Re: Case No. 21-277-EL-BGN - In the Matter of the Application of Border Basin I, LLC for a Certificate of Environmental Compatibility and Public Need to Construct a Solar-Powered Electric Generation Facility in Hancock County, Ohio.

Response to Fifth Data Request from Staff of the Ohio Power Siting Board

**BORDER BASIN I, LLC'S
RESPONSE TO THE FIFTH DATA REQUEST
FROM THE STAFF OF THE OHIO POWER SITING BOARD**

Figure No.
3-2

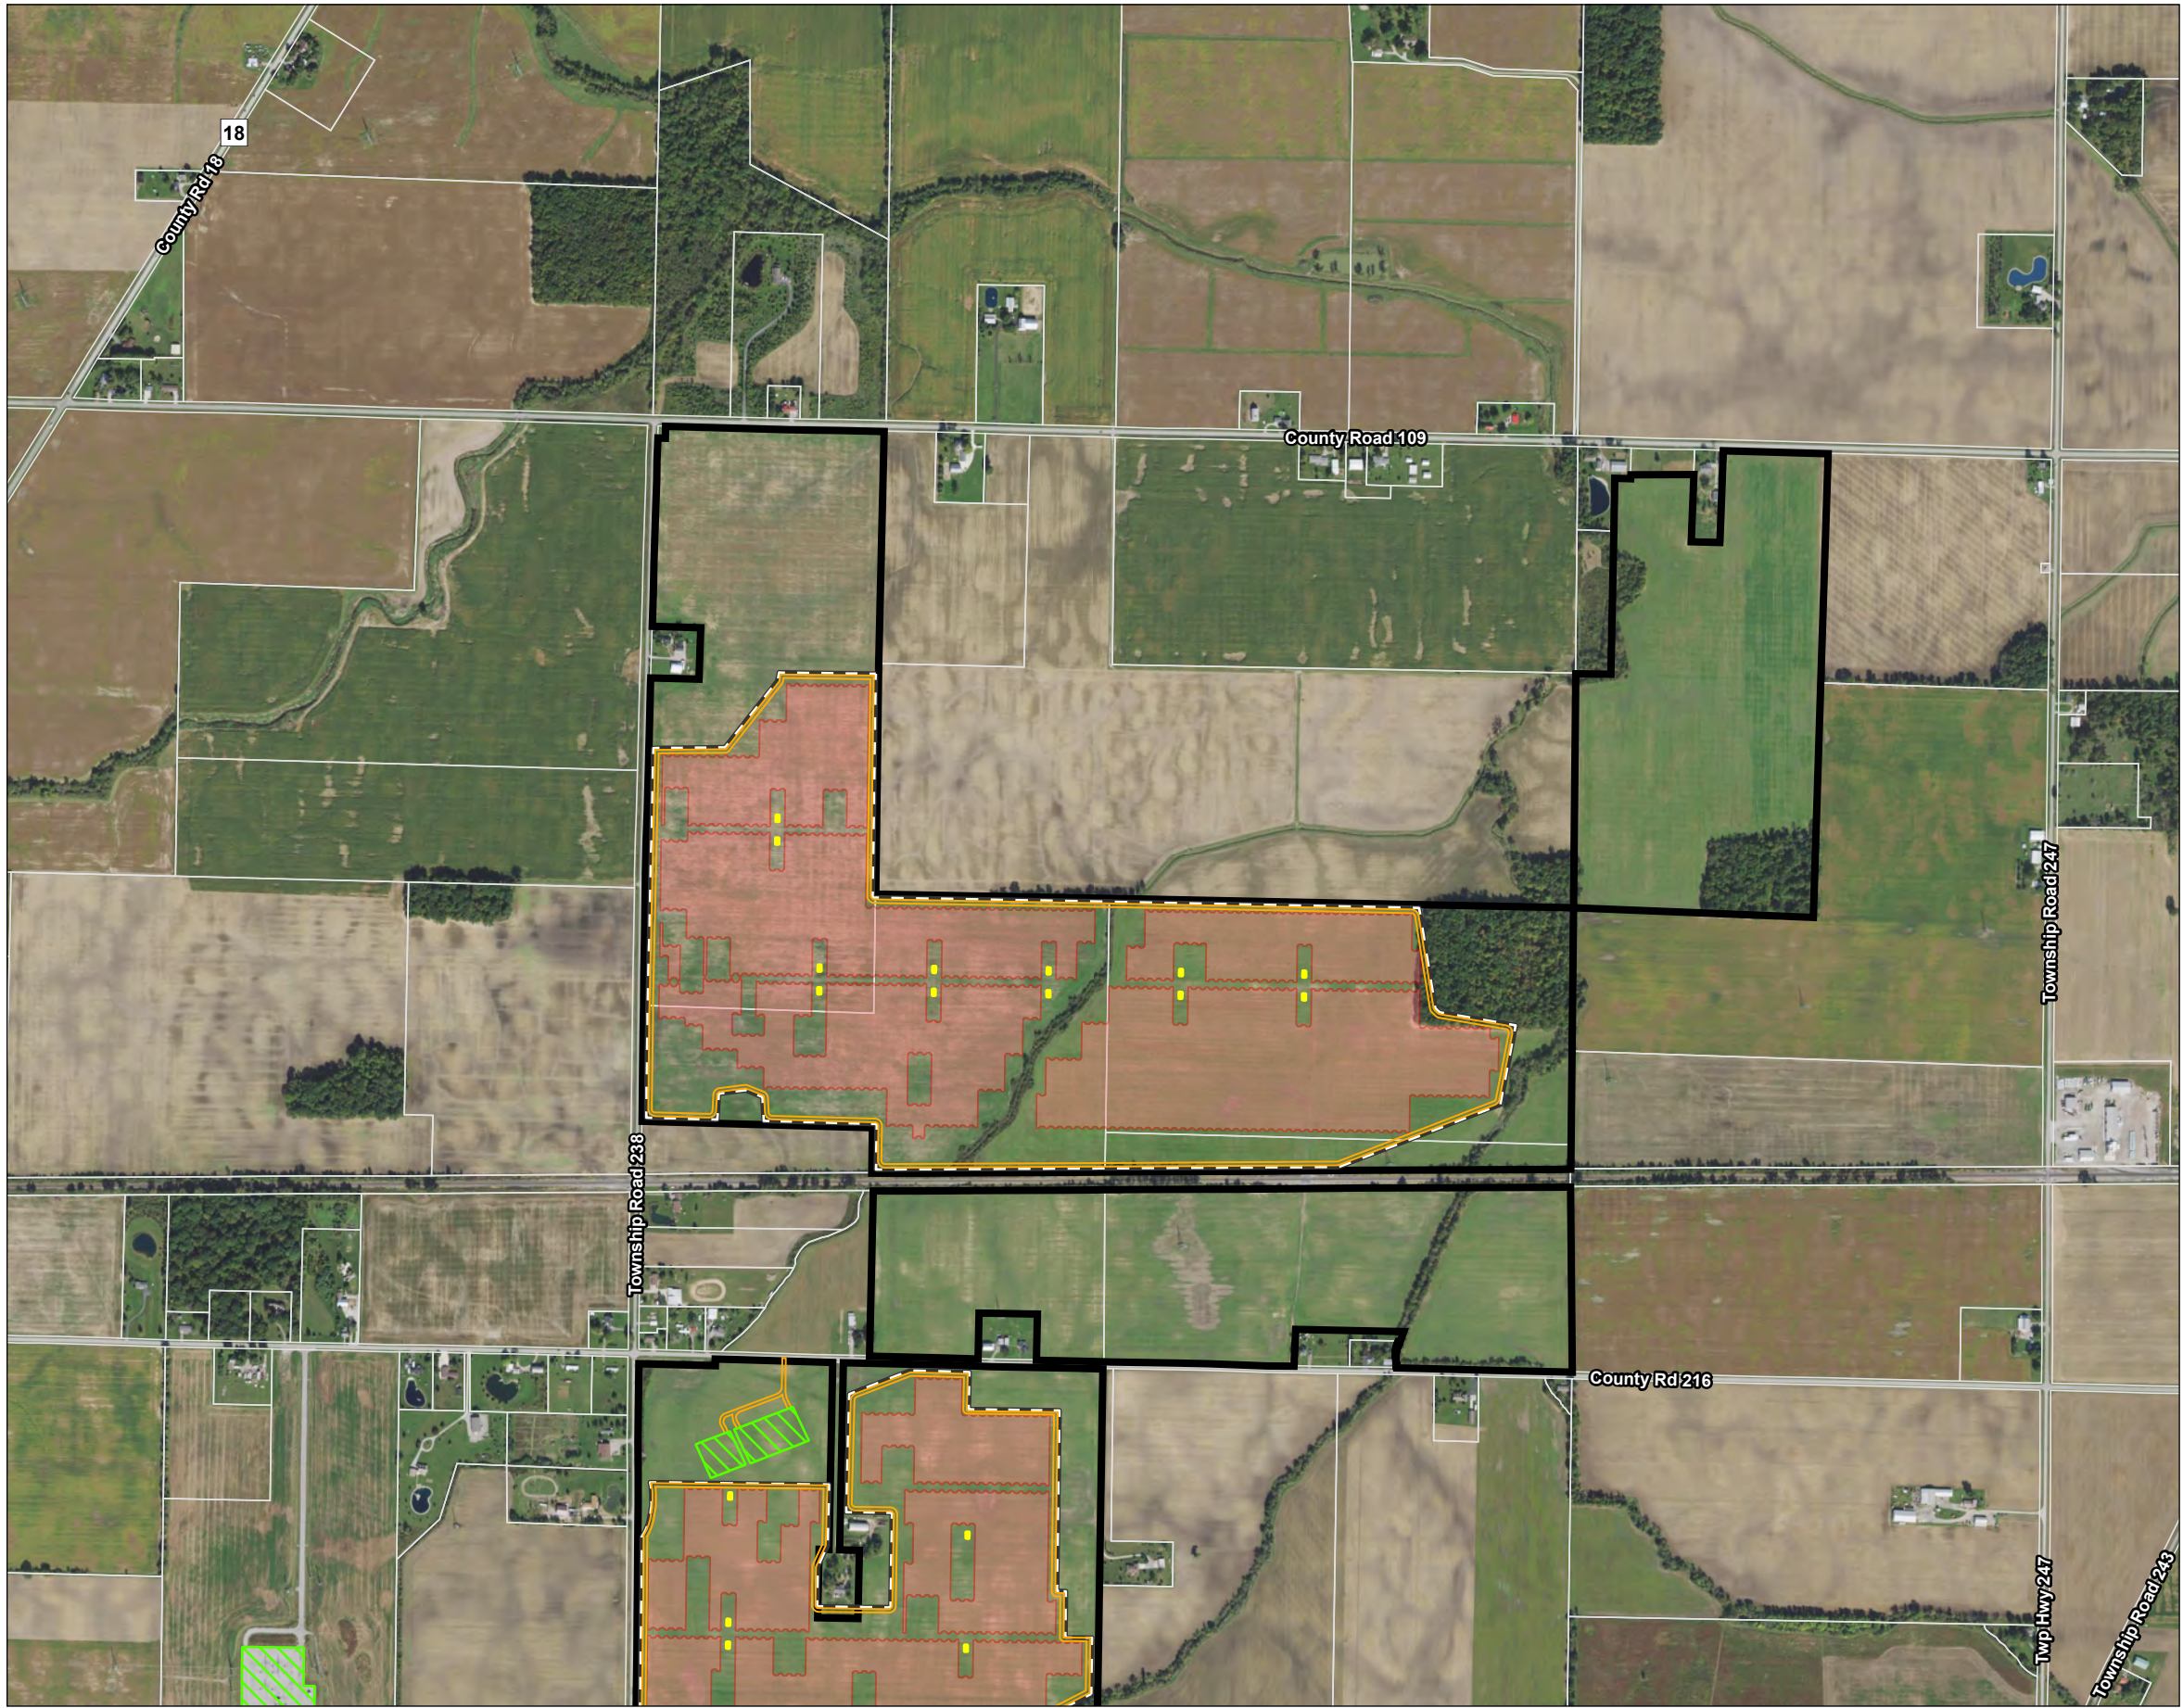
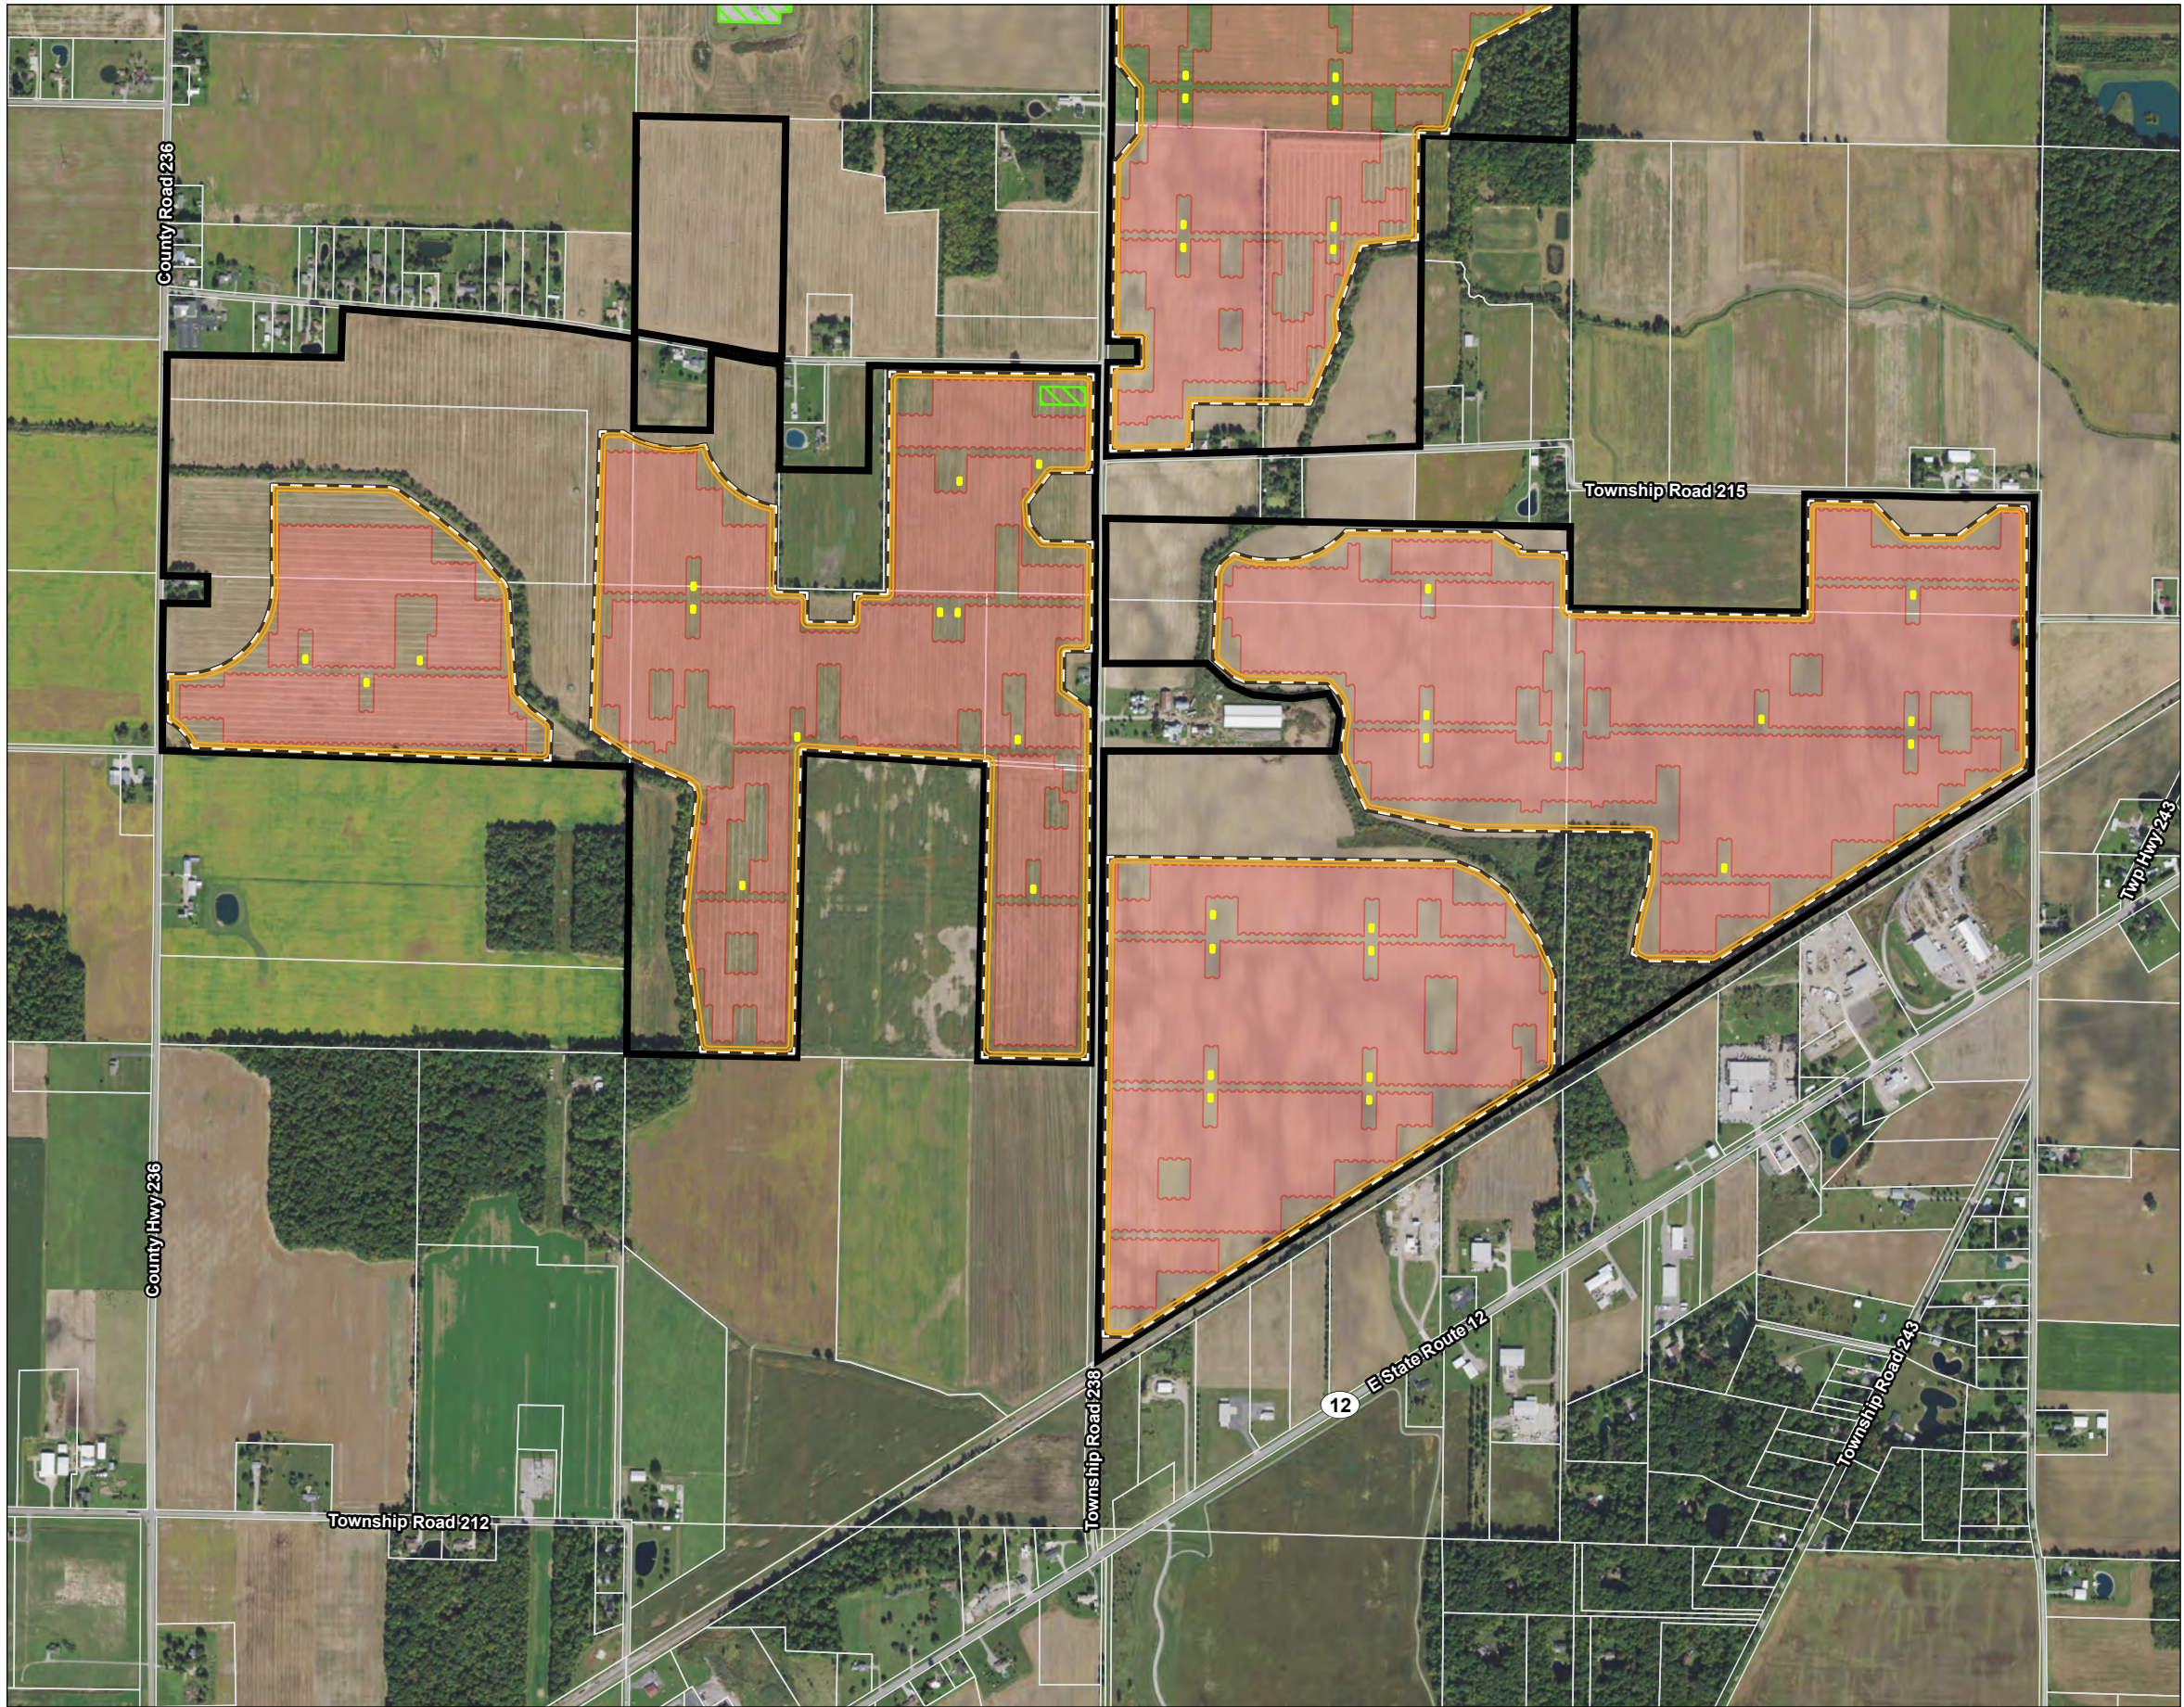
- Include a revised Figure 3-2 (Project Site Layout Map)
- Include a revised Figure 4-1 (Project Constraints Map)
- An explanation of what the Applicant would do if other oil/gas wells are encountered or found during construction;
- If the Applicant discovers the need to plug wells (prior to construction, during operation, or at the end of solar facility's life), include an analysis of the probable costs of construction or decommissioning; and
- Cost estimate to properly plug and abandon an oil/gas well.

Revised Figures 3-2 (Project Site Layout Map) and 4-1 (Projects Constraints Map) have been provided. These maps supersede all previous versions. In addition to the revisions that allow for a 50-foot or greater setback around each identified potential historical O&G well, the Project boundary has been updated to eliminate three parcels that are no longer part of the Project area. Removal of these three parcels does not alter any of the results nor conclusions of any of the studies or assessments included as part of the Application. The Project area now totals approximately 1,325 acres.
